CLUBSWAN 36

Notice #02/2024

Revised Foil Stop Position

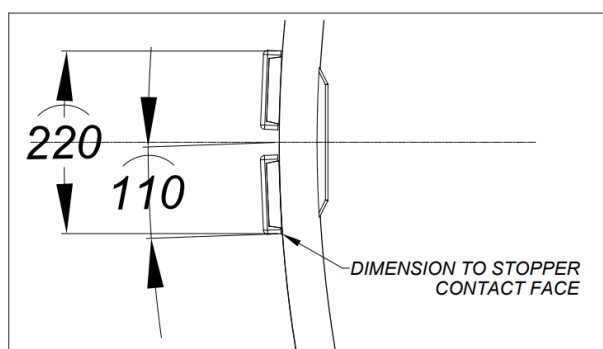
Further to the Class Rule amendment changing the limitation on the foil extension the separation of the existing foil stop blocks may be reduced to 220mm measured along the surface of the foil. (110mm either side of the foil centreline)

Distance Between Stopper Contact Faces

Minimum of 220mm - measured along foil surface.

Longitudinally, stoppers need to be placed at the same distance from the leading edge as currently installed, parallel to the leading edge of the foil to align with the existing slot in the central bearing.
